United States Patent and Trademark Office

APPLICATION	NO. F	TLING DATE	FIRST NAMED INVENTOR	ATTORNEY DOCKET NO.	CONFIRMATION NO.	
10/510,134 10/04/2004		10/04/2004	Christophe Blanc	0595-1009	6326	
466	7590	02/09/2006		EXAM	EXAMINER	
	G & THOMI		LEE, GUN	LEE, GUNYOUNG T		
2ND FL		IKEEI		ART UNIT PAPER NUMBER		
ARLING	GTON, VA	2202				
				DATE MAILED: 02/00/2006	DATE MAILED: 02/09/2006

Application No.	Applicant(s)	- 60 C					
Office Action Summary	10/510,134	BLANC, CHRISTOPHE						
omoc Addon Gammary	Examiner	Art Unit						
The MAILING DATE of this commun	Gunyoung T. Lee	2875						
The MAILING DATE of this commun. Period for Reply	icauon appears on the cover snee	with the correspondence address	S					
A SHORTENED STATUTORY PERIOD FOR THE MAILING DATE OF THIS COMMUNI - Extensions of time may be available under the provisions after SIX (6) MONTHS from the mailing date of this comm - If the period for reply specified above is less than thirty (3) - If NO period for reply is specified above, the maximum states a period for reply within the set or extended period for reply Any reply received by the Office later than three months a earned patent term adjustment. See 37 CFR 1.704(b).	CAT

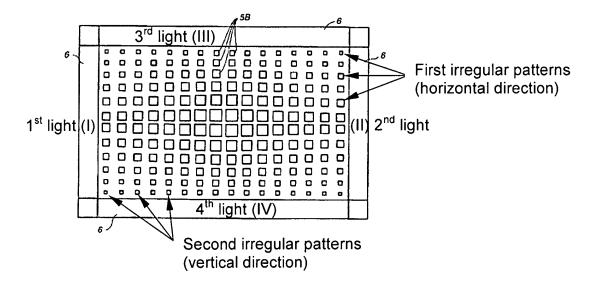
- Wherein first irregular diffusing patterns formed in the plate (Fig. 9) (as shown in the picture of page 6) (col. 5, lines 15-16);
 - Two light sources (Fig. 9, 6) arranged along two opposed side edges of the plate;

- At least one third light source (Fig. 9, 6) arranged along a third side edge of the plate;
 - Second irregular diffusing patterns (as shown in the picture on page 6) formed in the plate, which crisscross with the first diffusing patterns (col. 9, lines 18-20).

Akahane et al. discloses a LCD background lighting system (Fig. 9, as shown in the picture on page 6) having:

- At least one third light source (III in the picture on page 6) arranged along a third
 edge of a plate and a fourth light source (IV) arranged along a fourth edge;
- Wherein the light source (I, II, III, IV in the picture on page 6) consists of light emitting diodes (LEDs) (col. 5, line 11);
- Wherein the first pair of light sources (I, II in the picture on page 6) and the second pair of light sources (III, IV) are disposed in two essentially orthogonal directions.
